The Commission has issued the enclosed Amendment Nos. 93 and 61 to Facility Operating License Nos. DPR-51 and NPF-6 for Arkansas Nuclear One, Unit Nos. 1 and 2 (ANO-1 & 2). These amendments consist of changes to the Technical Specifications (TS) in response to your application dated October 31, 1980, as supplemented by letters dated August 23, 1983 and July 11, 1984.

The amendments revise the TS to incorporate hydrogen/oxygen concentration limitations and hydrogen/oxygen monitoring requirements in the ANO radioactive waste gas systems.

SAFETY EVALUATION BY THE OFFICE OF NUCLEAR REACTOR REGULATION
SUPPORTING AMENDMENTS NOS. 93 AND 61 TO FACILITY OPERATING LICENSES

ARKANSAS NUCLEAR ONE, UNITS 1 AND 2

HYDROGEN %
FIGURE 3.2 4-1
HYDROGEN - OXYGEN LIMITS FOR ANO-1
WASTE GAS SYSTEM

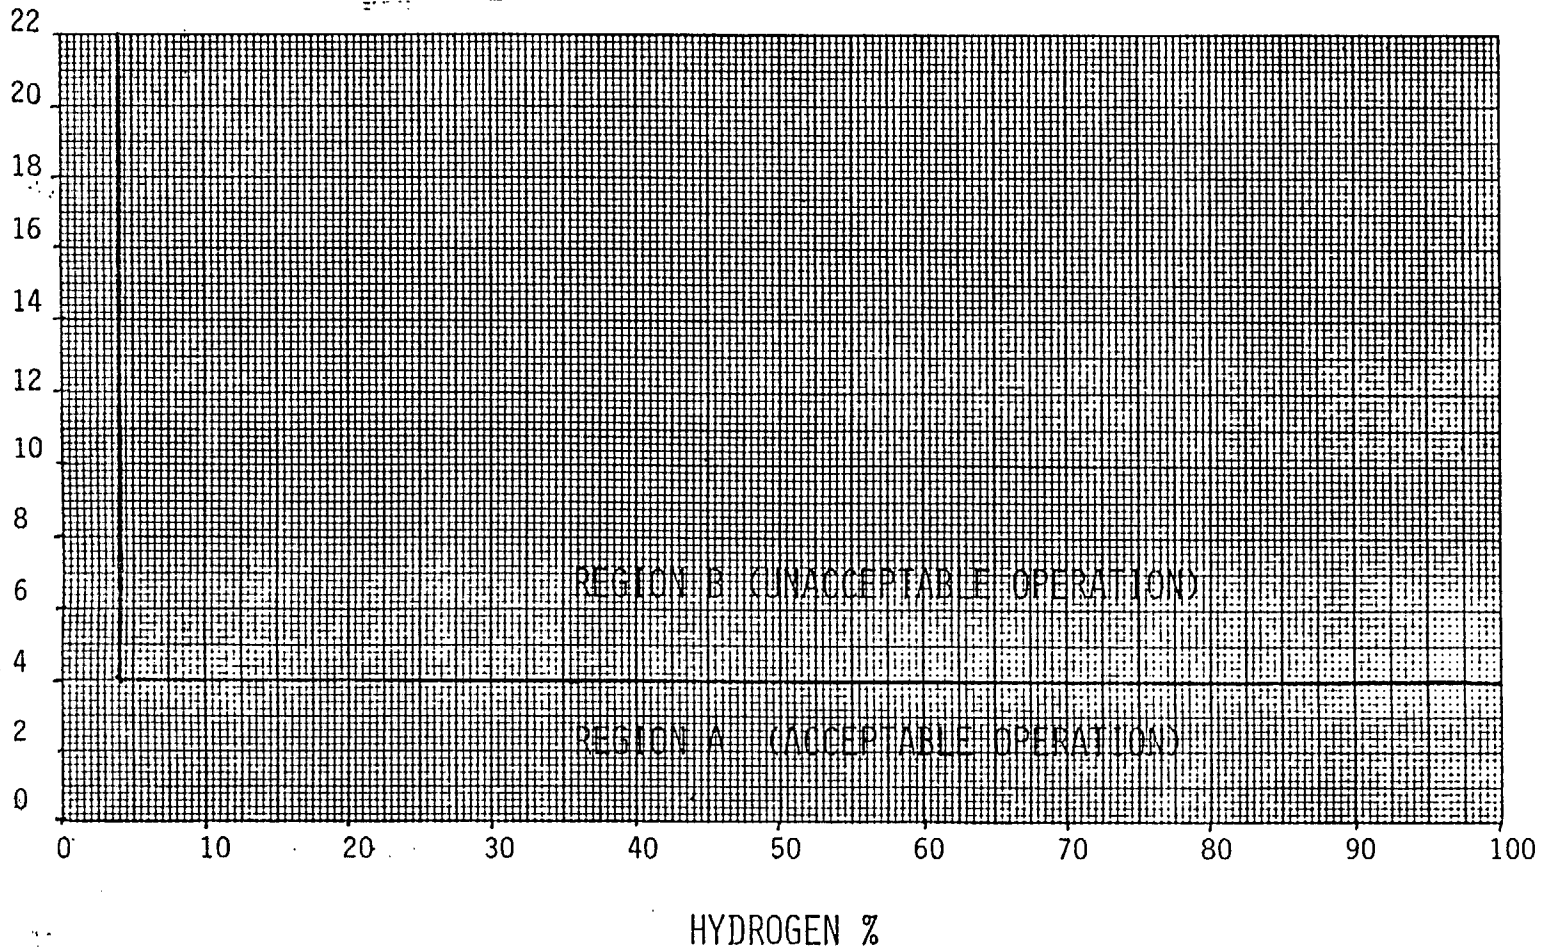
- 3.24.1 The concentration of hydrogen/oxygen shall be limited in the waste gas decay tanks to Region "A" of Figure 3.24-1.
- 3.24.2 When the hydrogen/oxygen concentration in any of the decay tanks enters Region "B" of Figure 3.24-1, corrective action shall be taken to return the concentration values to Region "A" within 24 hours.
- 3.24.3 The provisions of Specifications 3.0.3 and 3.0.4 are not applicable.

This specification is to assure that the hydrogen/oxygen concentration will be kept within the limits in Figure 3.24-1 and therefore not enter the flammable region concentrations in the waste gas decay tanks.

FIGURE 3.11-1

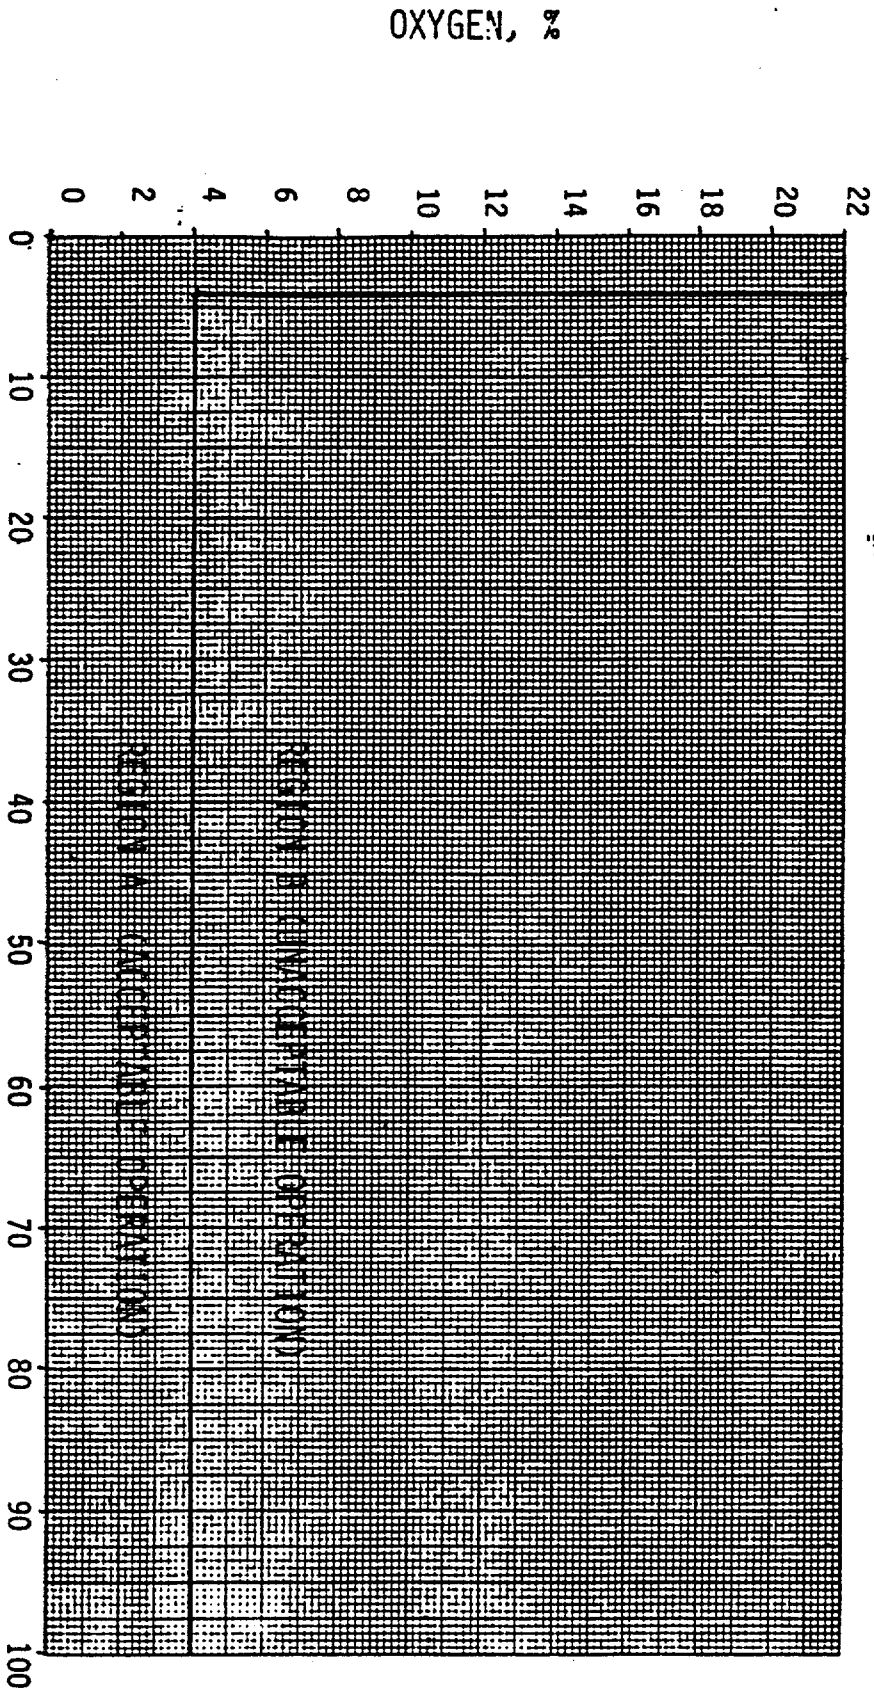
3.11.2.7 The concentration of the hydrogen/oxygen shall be limited in the waste gas storage tanks to Region "A" of Figure 3.11.1.

- a. When the concentration of hydrogen/oxygen in the waste gas storage tanks enters Region "B" of Figure 3.11-1, corrective action shall be taken to return the concentration values to Region "A" within 24 hours.
- b. The provisions of Specifications 3.0.3 and 3.0.4 are not applicable.

Grab samples are to be taken every 4 hours during degassing operations when both hydrogen/oxygen analyzers are out of service. These samples are to be analyzed within 8 hours to assure that the hydrogen/oxygen concentration is within the limits in Figure 3.11-1. During other Waste Gas Compressor operations, the hydrogen/oxygen concentration is not as subject to change, therefore grab samples are to be taken every 24 hours.
